Conceptual Review Agenda

Schedule for 02/22/16 to 02/22/16

Patton and Elizabeth Multi-family

CONCEPTUAL SITE PLAN

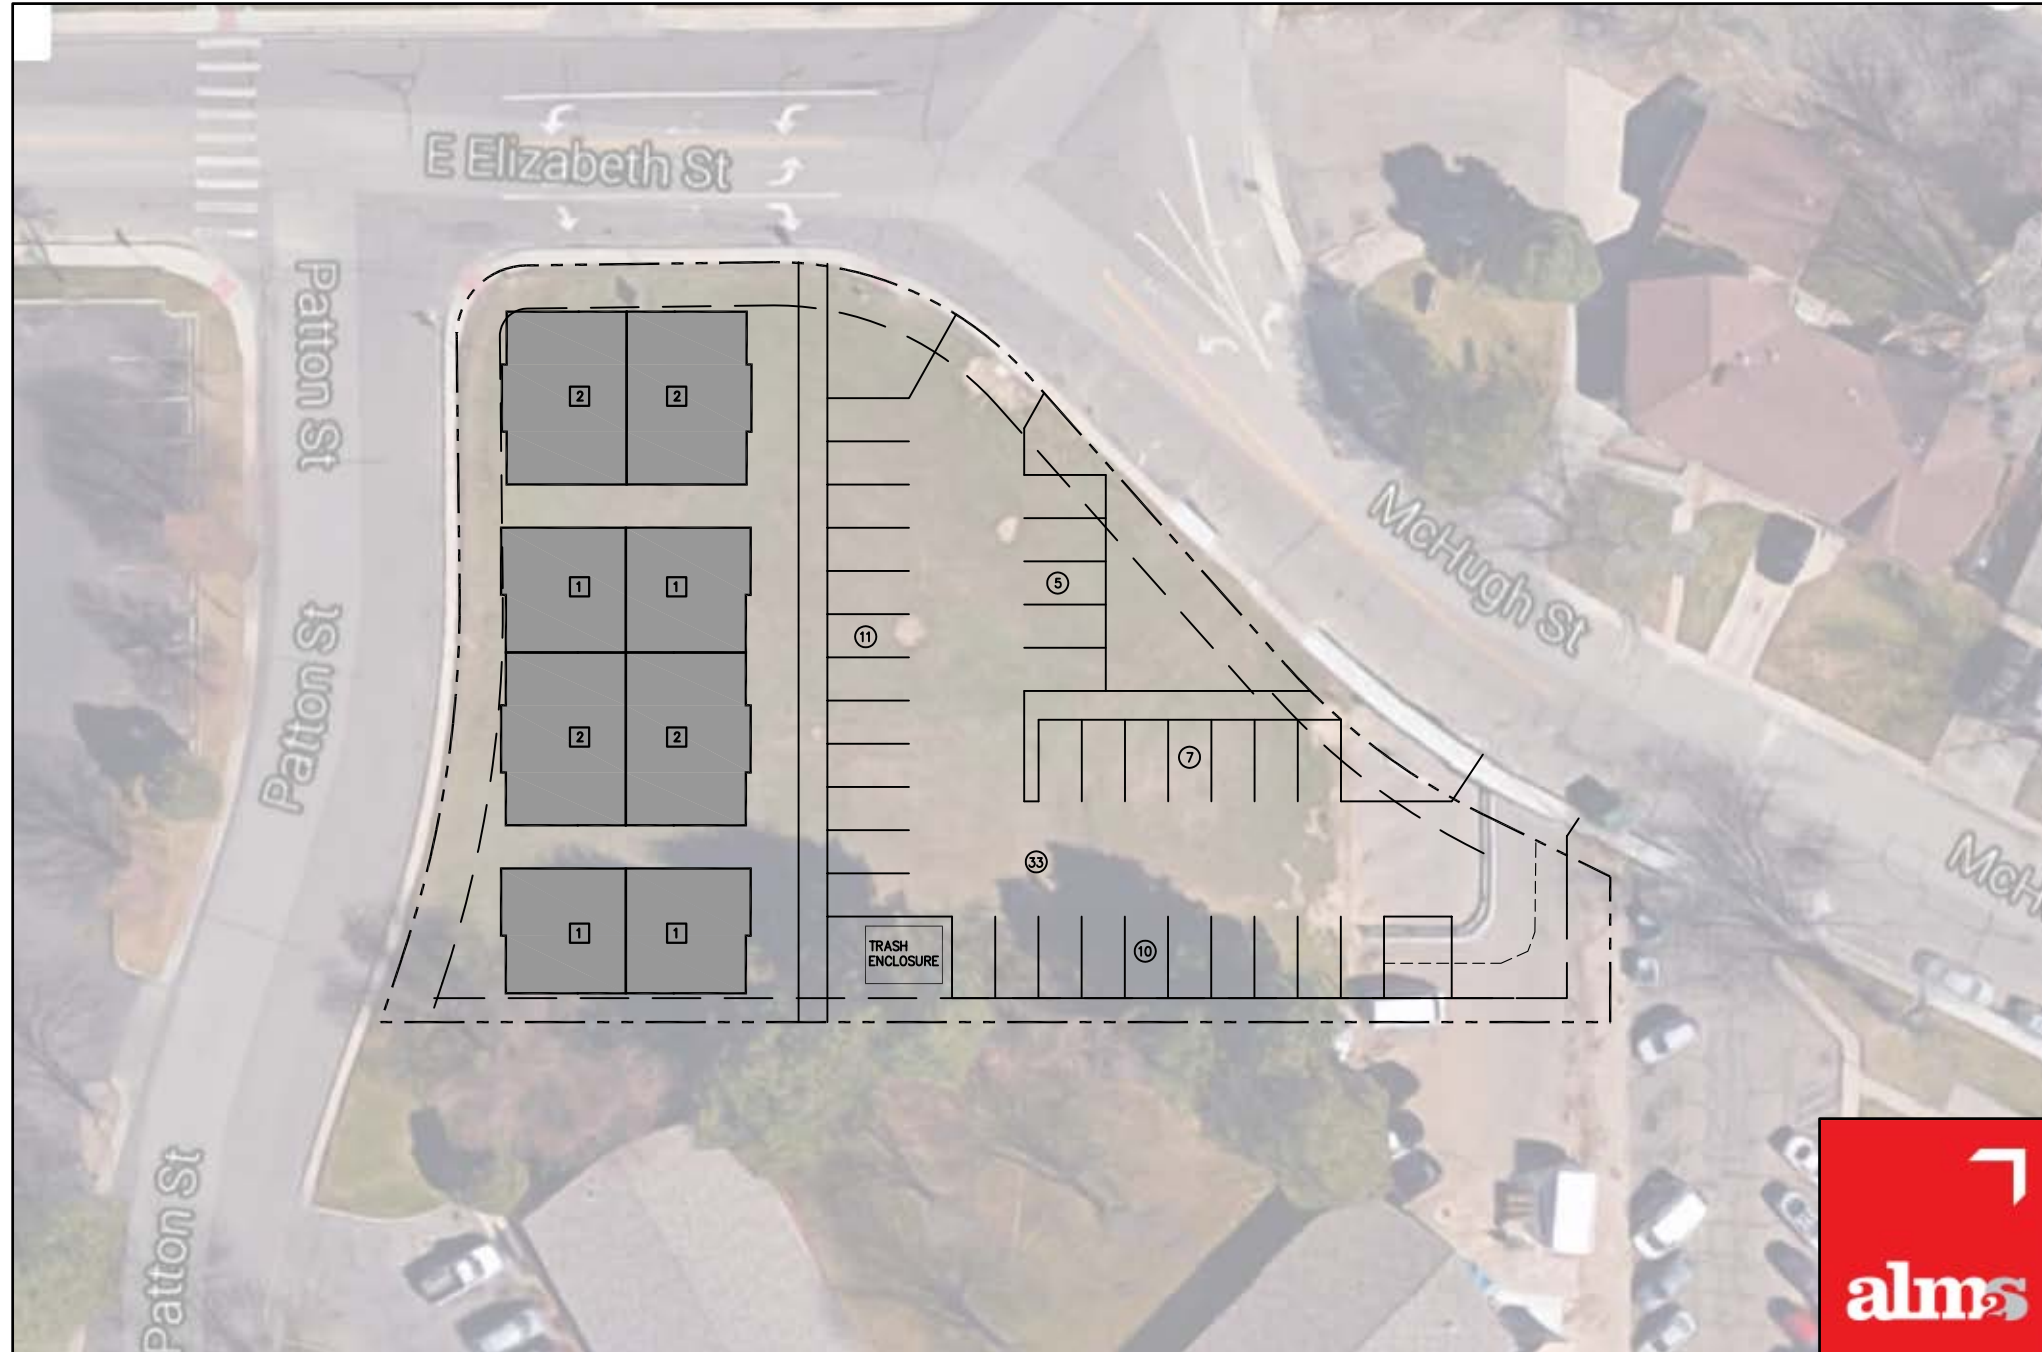
Additional fire lane requirements apply to any building exceeding 30' in height. Depending upon footprint orientation, the current site plan may be compliant. Applicant to verify this requirement has been met. Code language provided below.

1. This property is in the E (Employment) zone district. In the E Zone residential uses are secondary uses. Secondary Uses are limited to 25% of the total gross area of the development plan.
2. The max height of a buildnig in the E zone is 4 stories.

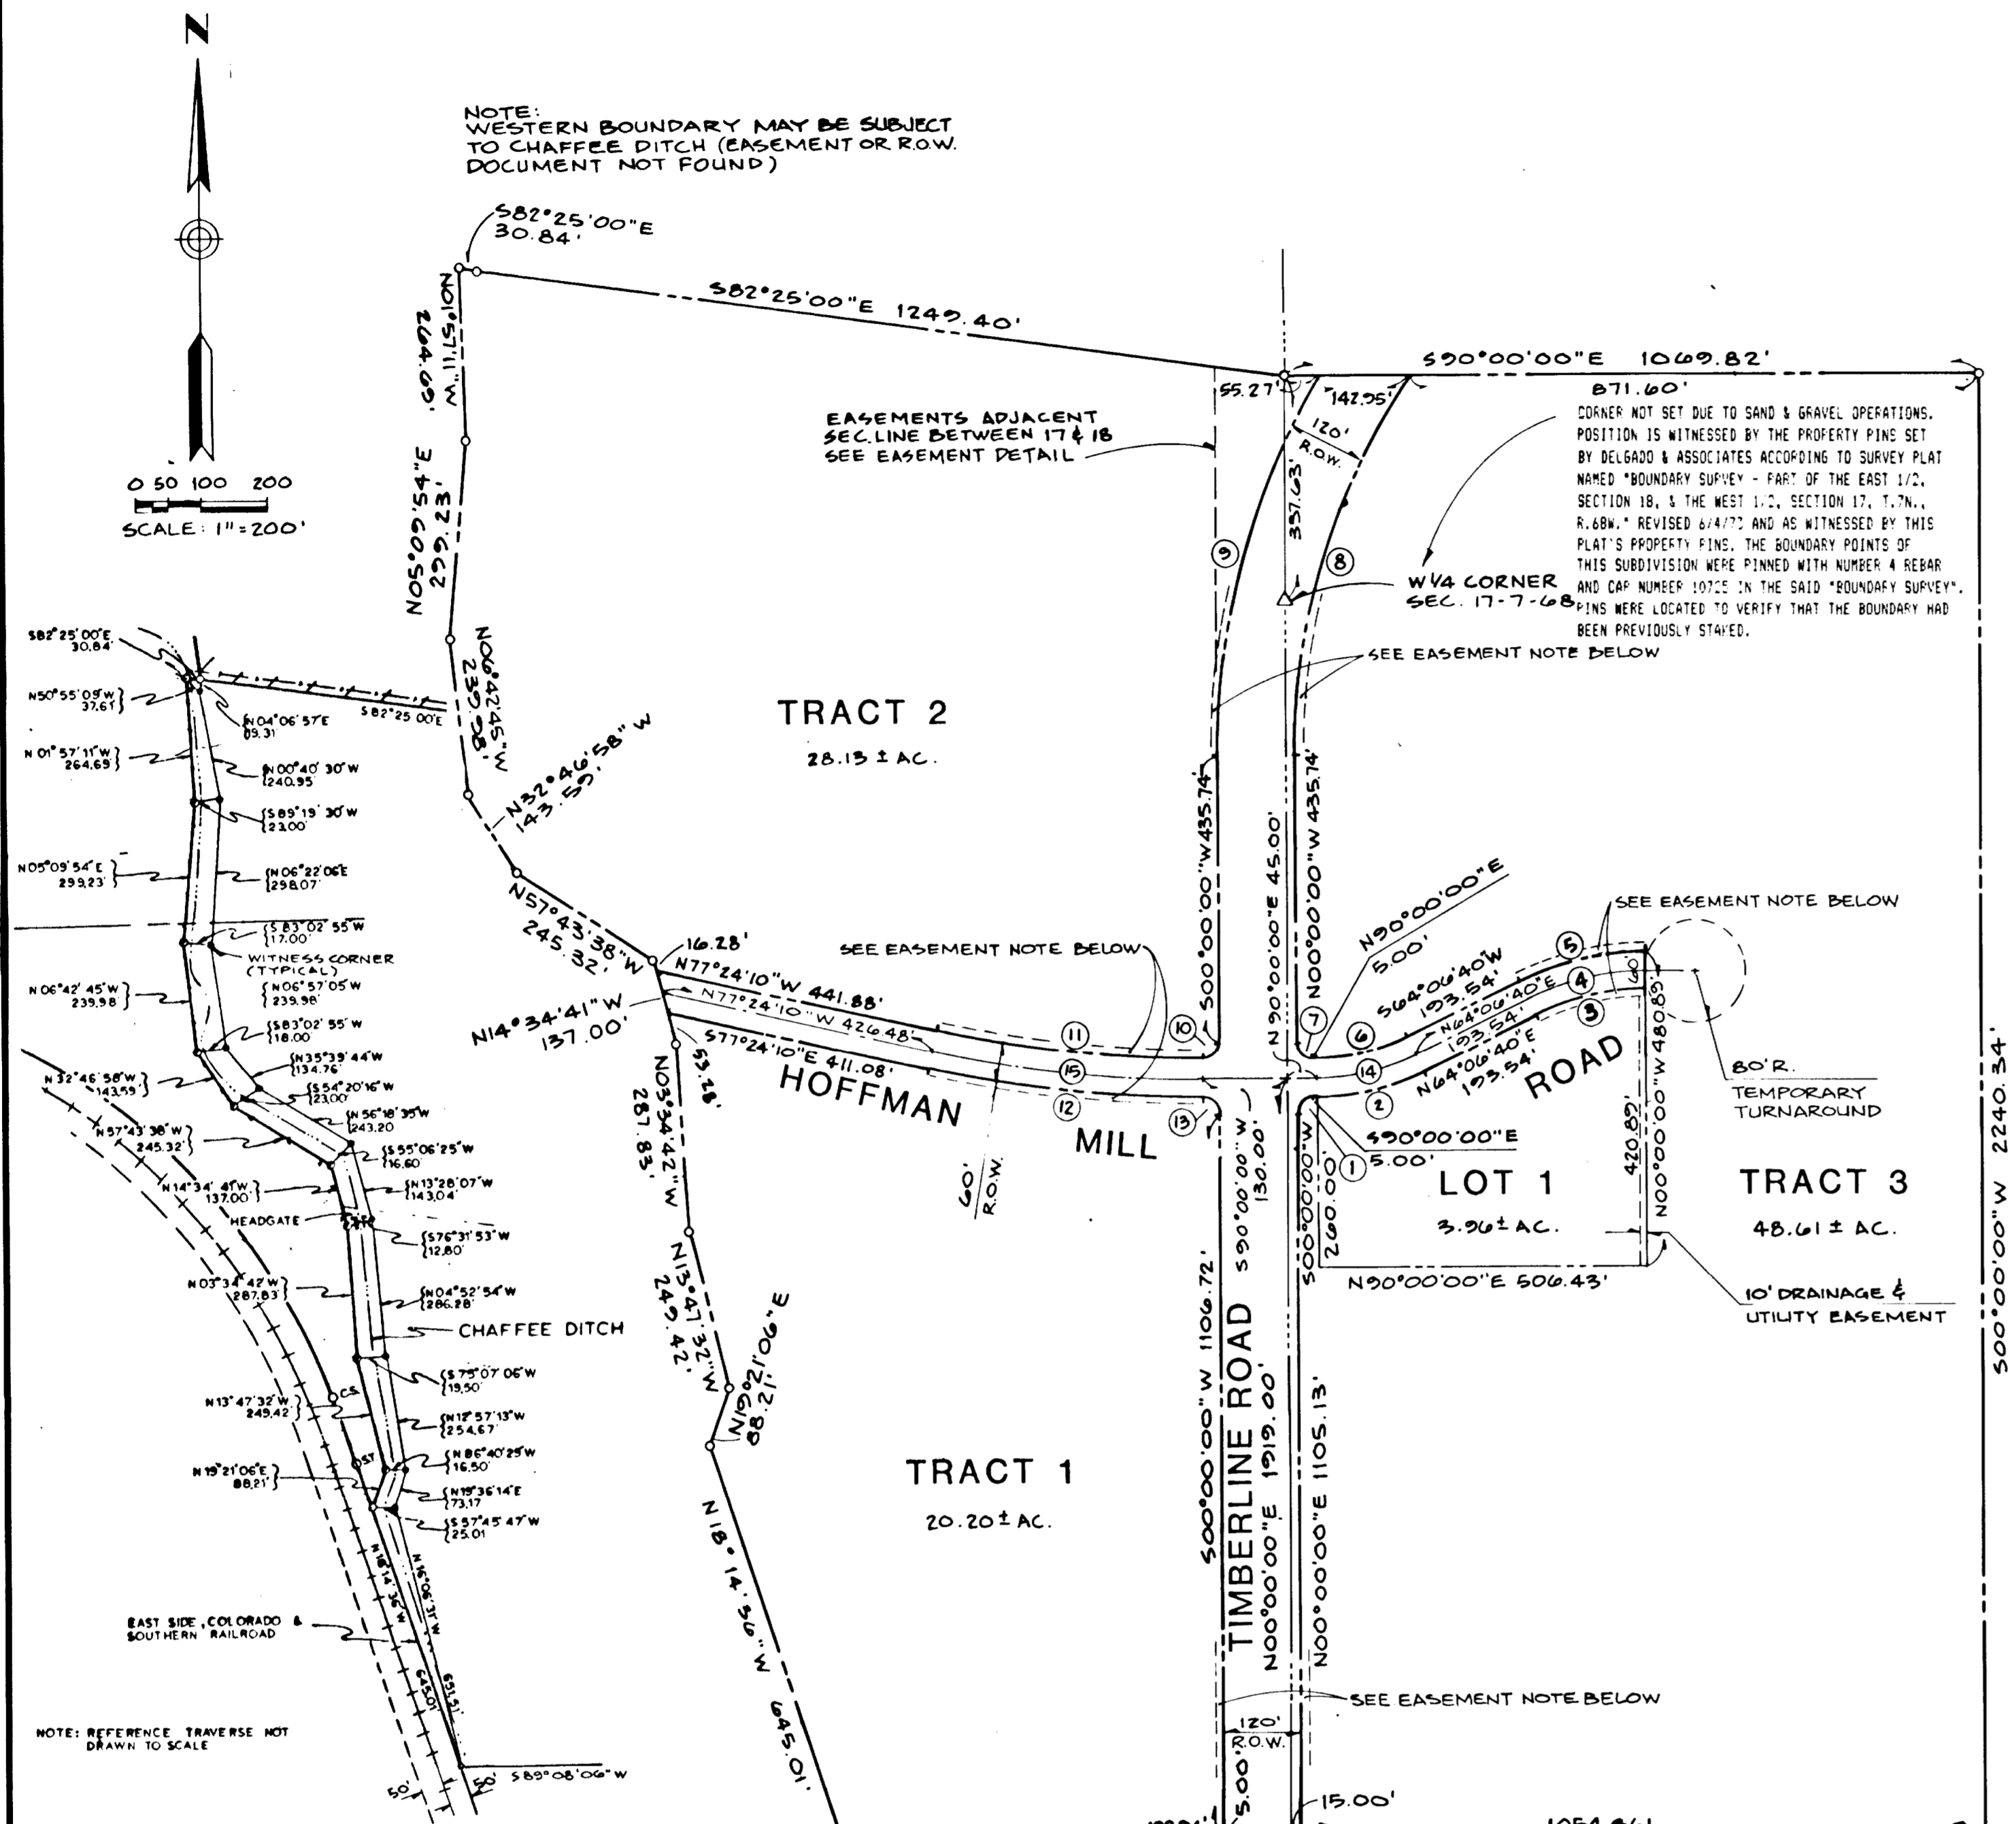
10. Access as it is laid out looks like it is close to the minimum standard spacing (460' from driveway edge to the south). Minimum should be met with final design. A modification to the Land Use Code will be necessary for full movement access <1320' from Prospect.

2. Can the site plan be arranged such that there are two access points onto Timberline Road? With 228 units, will only one access be sufficient? While traffic engineering may call for deceleration lanes for ingress, perhaps acceleration lanes for egress should also be considered given the nature of traffic on northbound Timberline Road.

8. The layout of the buildings appears to be regimented. Please explore options that would mitigate this and add interest and variety to the placement of buildings.
